ATTACHMENT 4A

Emergency Plan Marked-up Pages – Dresden Station

Exelon Standardized Emergency Plan EP-AA-1000
and
Emergency Plan Annex EP-AA-1004

Figure B-1a: Exelon Overall ERO Command Structure

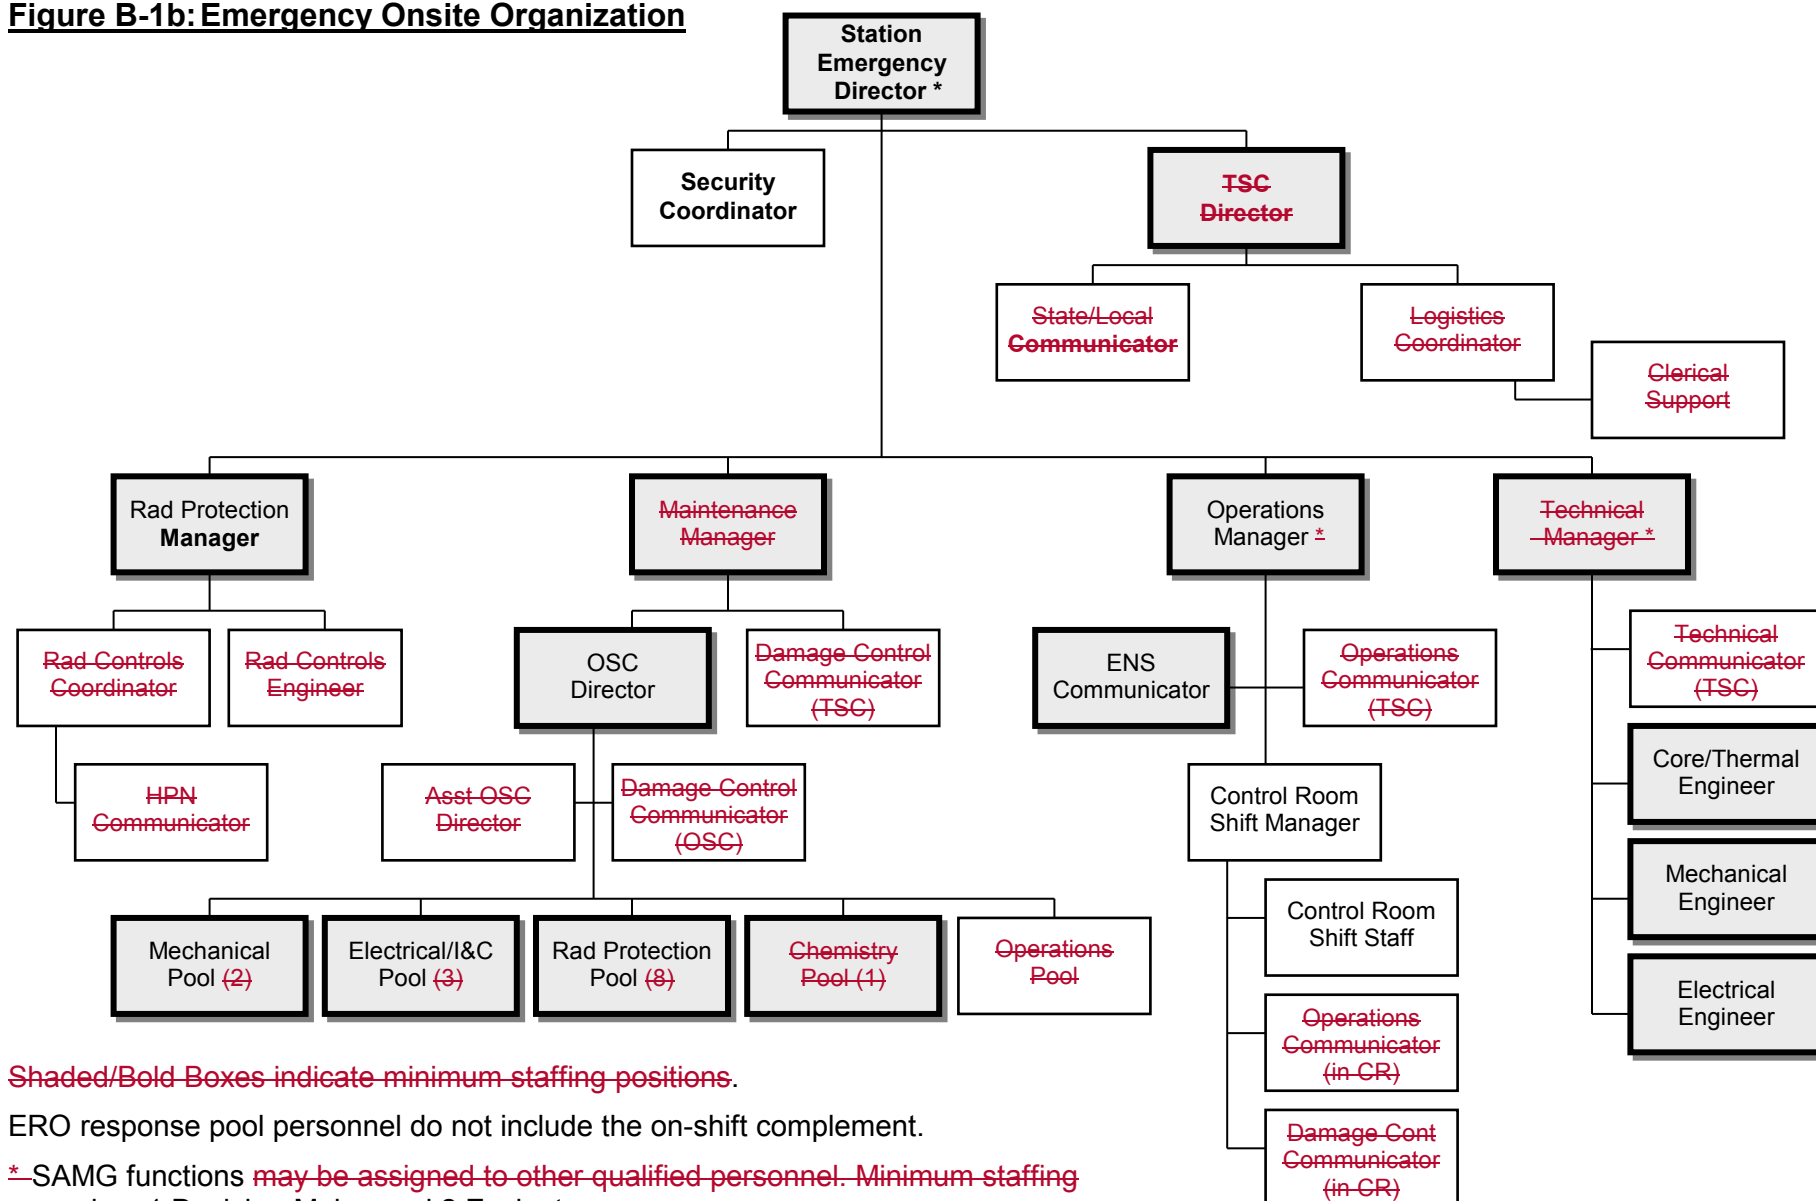
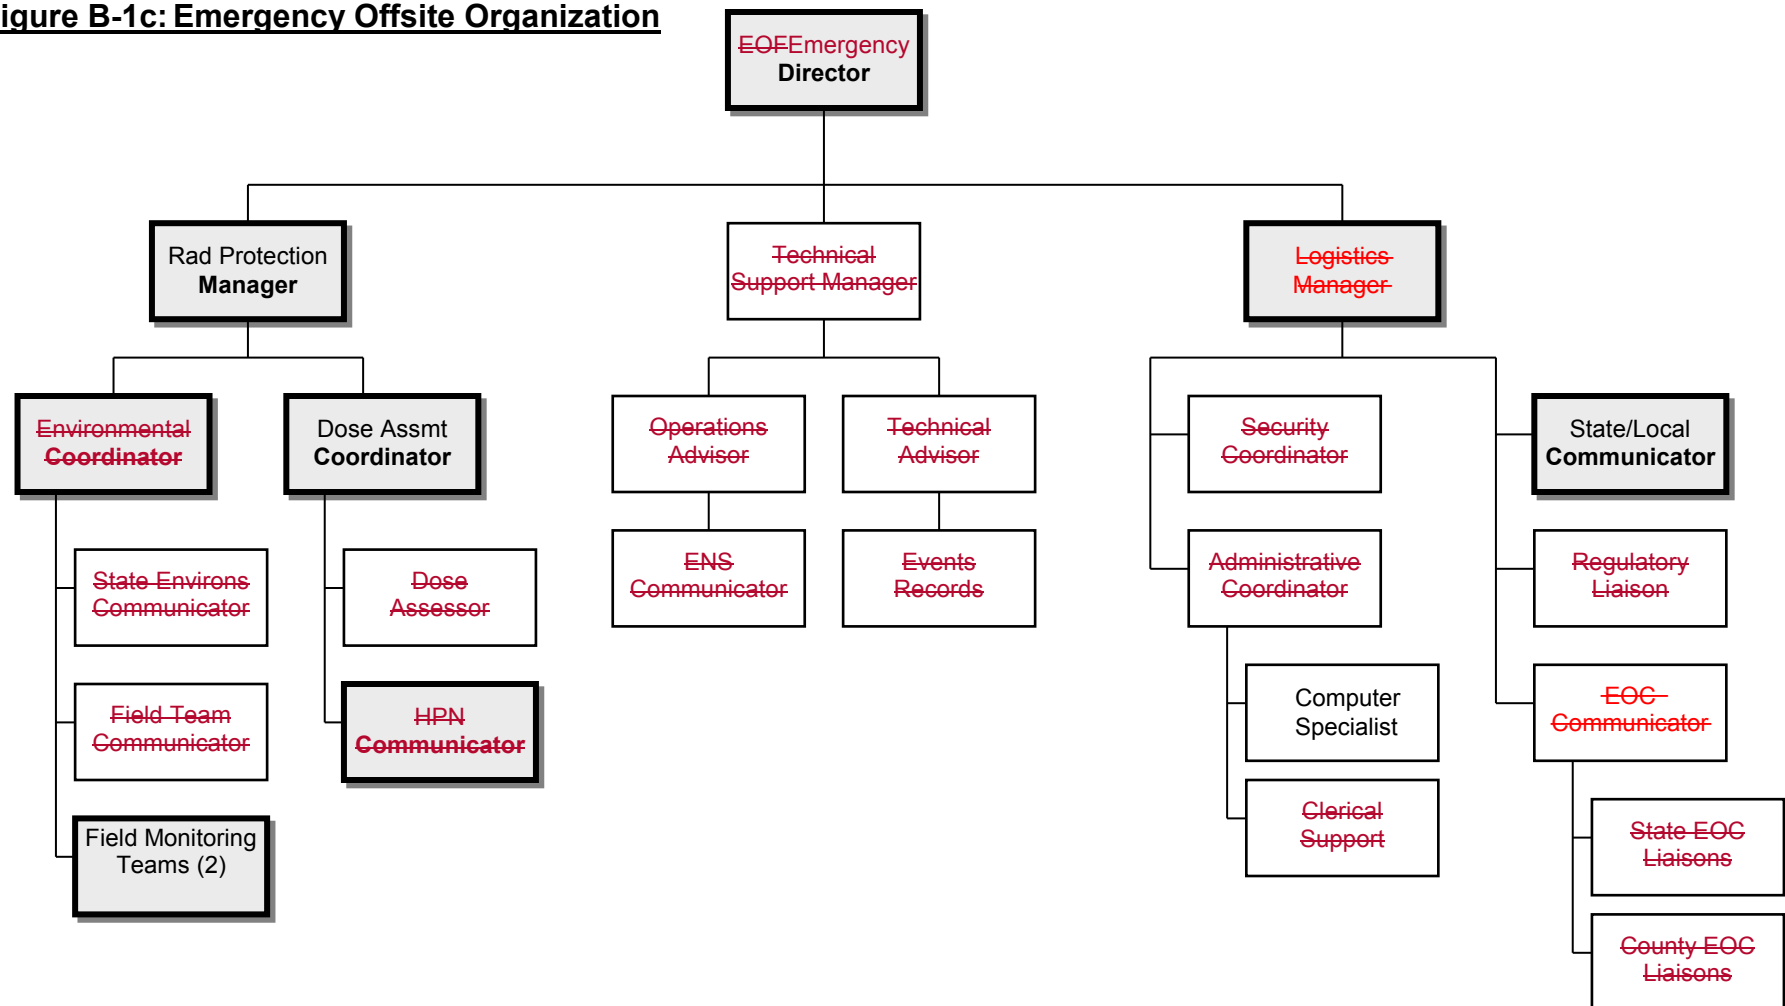
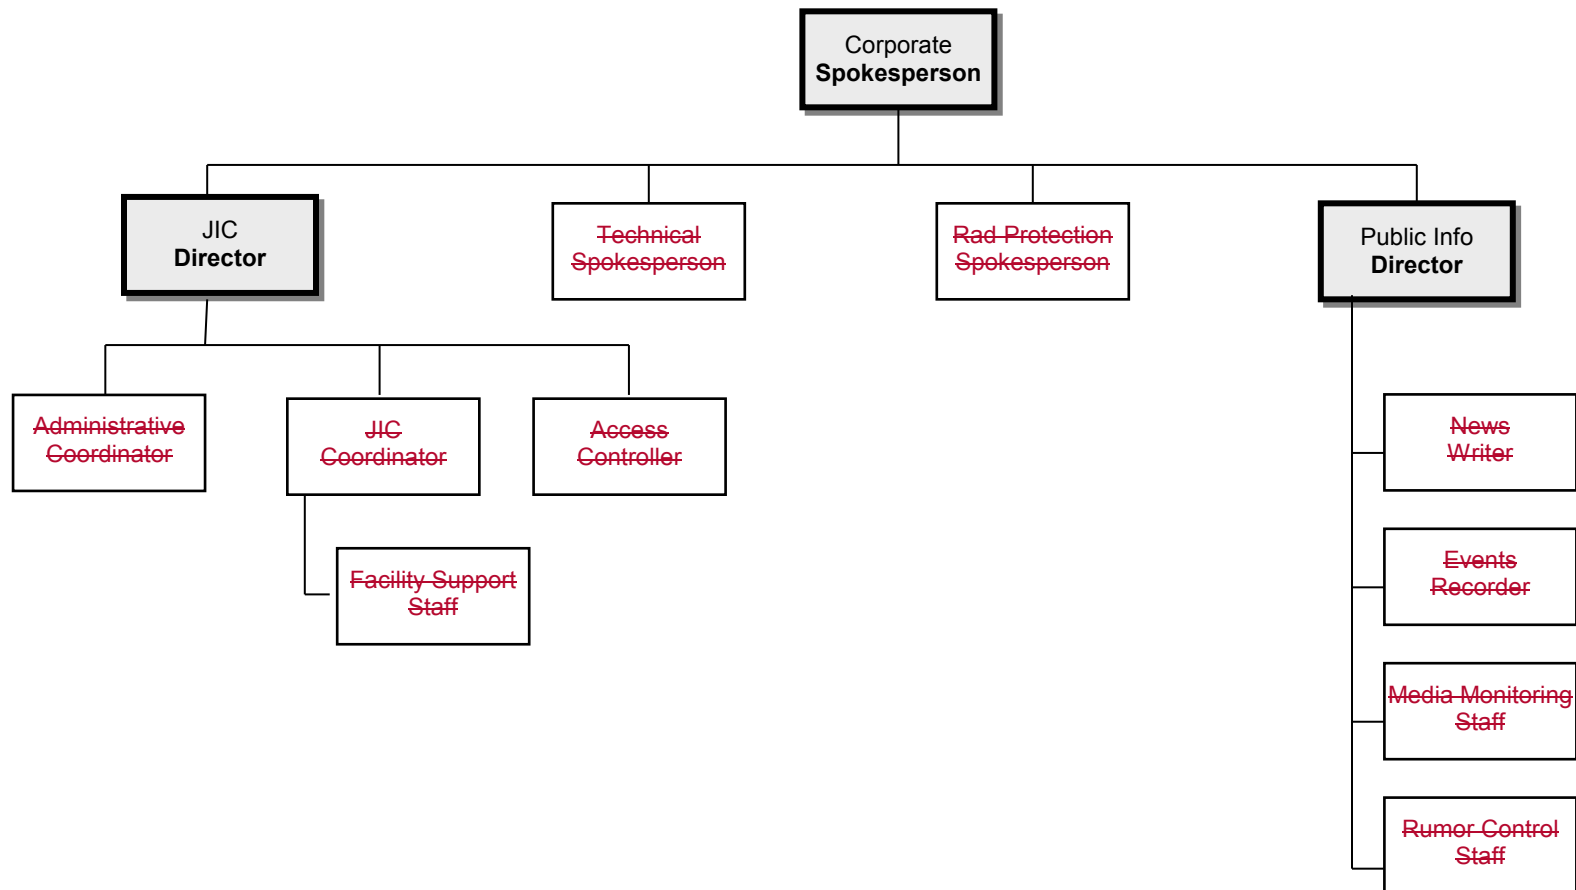
ERO staffing tables contained ~~within the station specific Annexin Appendix 5,~~ lists the key positions of the ERO ~~and the supporting positions assigned to interface with federal, state, and county authorities.~~ Figures B-1a through B-1d illustrates the overall emergency response organization. Section B.5 discusses specific responsibilities and the interrelationships for key positions.
